JACKS AND PLUGS IDENTIFICATION AND SERVICE

1.001 This addendum supplements Section 461-630-100, Issue 10. Place this pink sheet ahead of Page 1 of the section.

1.002 This addendum is issued to add information on the 101A sleeve and to show the 43B bracket MD.

Fig. 32—63B Bracket With 101A Sleeve Installed

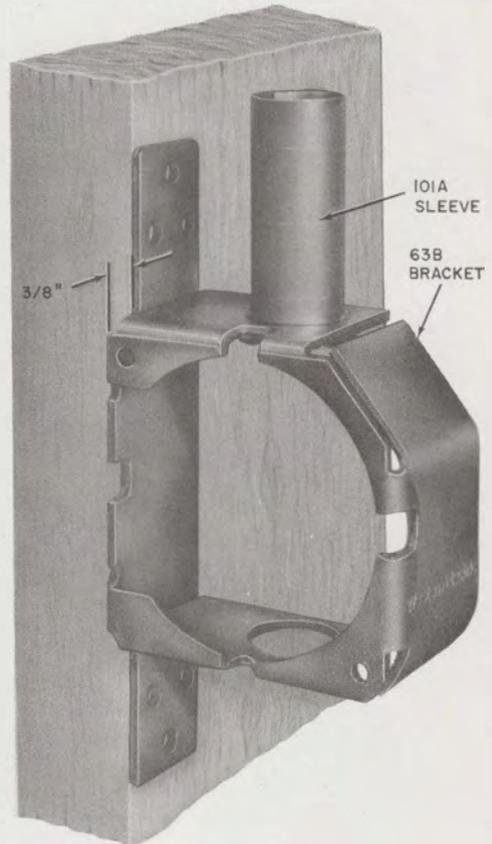
2.06.1 The 101A sleeve (Fig. 32) is used to protect the prewiring while the drywall is being cut around the 63B bracket as the drywall is being installed on the studing. The metal tube snaps into either access hole of the bracket before the wiring is placed.

2.002 On Page 20, Fig. 32 is obsolete. A new Fig. 32 is shown in this addendum.
